Reply on RC1:

Reply on RC2:

Reply on CC1:

Fig. 9 performance loss for the Chinese railway system using national-scale flood footprints (a) daily affected trains and (b) daily affected passengers

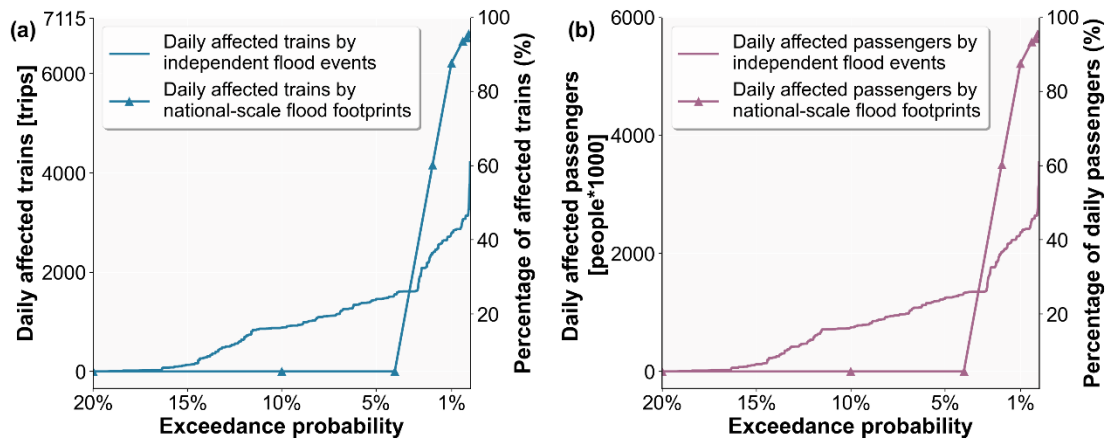
3) In discussion, only text is listed in this part, it is suggested to make a comparative analysis by subject in order to strengthen the practicability and expansibility of the proposed method and framework.

Response: We thank the reviewer for the suggestion. In the revised manuscript, we have made a comparative analysis in the discussion part to strengthen the practicability and expansibility of the proposed method and framework. We have added the following description in lines 3-21, page 34 and line 1, page 35:

In the broader context of risk assessments for the transportation systems, the simplified method for generating independent flood events offers a practical method for large-scale performance losses and indirect risk assessment. Most existing studies used regional- or national-scale flood footprints to assess flood induced risk. However, the presented floods in such a flood footprint may not all happen at the same time. For comparison, we calculated the performance loss for the Chinese railway system using national-scale flood footprints (2, 5, 10, 25, 50, 100, 250, 500 and 1000 years in whole China) as shown in Fig. 9 a) and b). Results show that the performance loss for both affected train trips and passengers is almost unaffected for national-scale flood footprints with a return period below 25-years. While performance loss sharply increases when the flood hazard return period exceeds 50-years. More than 90% trains and passengers would be affected when the flood hazard return period exceeds 100-years,. Compared with the performance loss obtained by generated independent flood events, the results given by national-scale flood footprints are underestimated for small intensity flood events and overestimated for large intensity flood events. Therefore, when assessing possible cascading effects, the use of independent flood events is necessary (Nones and Pescaroli, 2016).

Fig. A1 (a) the 50-year flood, (b) the 500- year flood

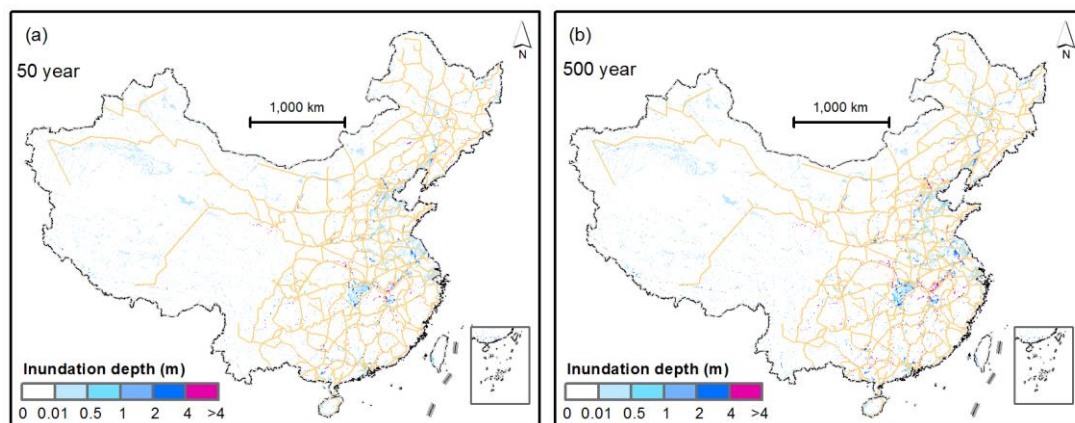
3) In Data and Method section and sect 2.1.1, the global flood hazard model should be better described (also providing some examples in the SM). All the adopted metrics should be defined much more carefully, with a more precise and effective use of terms. For instance, only the trains where passenger travel can be cancelled or detoured, while passengers cannot be cancelled or detoured; so the metrics named 'passenger cancelled induce' or 'passenger detoured' in my opinion should be renamed (and better defined at their first appearance in the text).

Response: We thank for the reviewer’s suggestions. In the revised manuscript, we have added more details on the global flood hazard model and providing the flood maps on 50 and 500-year events in supplement materials in lines 10-20, page 9 and lines 1-4, page 10. Adopted metrics have been redefined and please refer to our response to Question 4.

Our flood hazard data are extracted from the GLOFRIS global fluvial flood hazard maps of Winsemius et al. (2013), which are developed using the GLOFRIS modelling cascade provided in Ward et al. (2013) and Winsemius et al. (2013). The GLOFRIS modelling cascade first simulates daily discharge using the PCRaster GlobalWater Balance (PCR-GLOBWB) global hydrological model [Beek and Bierkens, 2008; Beek et al., 2011]. Based on daily discharge, daily flood volumes are simulated using the PCR-GLOBWB extension for dynamic routing, DynRout (PCR-GLOBWB-DynRout) [Ward et al., 2013; Winsemius et al., 2013]. In the next step, flood volumes, for different return periods: 2, 5, 10, 25, 50, 100, 250, 500 and 1000 years, are obtained using the annual year time series for maximum flood volumes by fitting a Gumbel distribution. These flood volumes are then converted into inundation maps (30-arcsecond, ca. 1-km) using the inundation downscaling model of GLOFRIS [Winsemius et al., 2013]. In the appendix materials, we provide flood maps of 50 and 500-year events. Maps show that the inundation depth highly varies in China. Railway lines in eastern coastal China and South China are faced with the most severe floods.

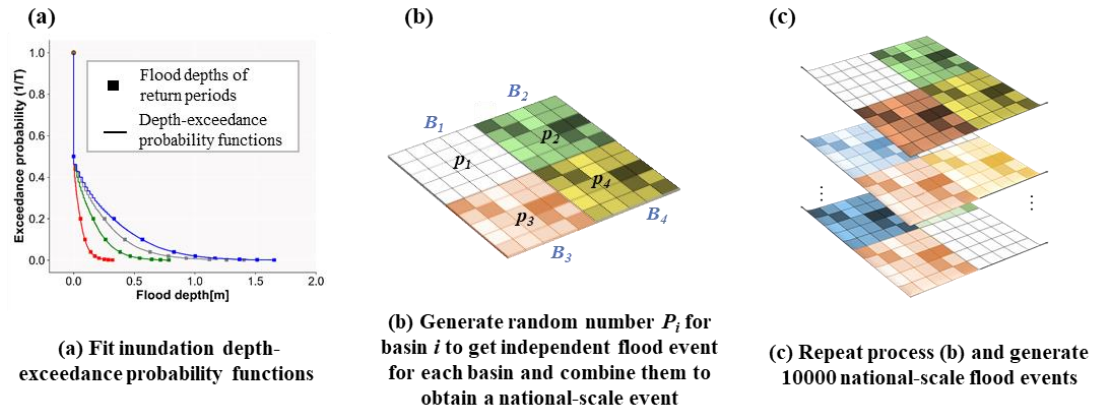
4) The description of the fitting procedure (Sect.2.1.2) must be improved. Figure 2a is rather unclear to me, and the caption does not help the readers. Moreover, its size is too small and the inset legend cannot be read (similar problems are present also in Figures 5, 6 and 7). I would suggest to

place the four graph in figure 2 in a 2 x 2 grid, enlarging each graph. Caption must be more clear for figure 2a and more concise for figs 2b, 2c and 2d.

Response: We apologize for the unclear description and thanks for your suggestions. In the revised manuscript, we have rewritten Sect 2.1.2 in lines 10-20, page 10, page 11, and lines 1-4, page 12. At the same time, Figure 2a as well as Figures 5, 6, 7 have been improved as followed.

For each grid cell, the GLOFRIS maps estimate the flood depth for the nine aforementioned return periods (2, 5, 10, 25, 50, 100, 250, 500 and 1000 years). To estimate the flood depth for any return period, we fit a quadratic spline function to develop an inundation depth-exceedance probability function (P) for each return period interval for each grid cell (Marsden, 1974; Vandebogert, 2017; Meshram et al., 2018). The quadratic spline is a method that uses a piecewise quadratic function to obtain the best-fitting curves. This interpolation method allows us to obtain a smooth continuous curve through the provided flood depths for the different return periods.

The method is applied as follows and examples of the inundation depth-exceedance probability function of grid cells are shown in Fig. 2a:
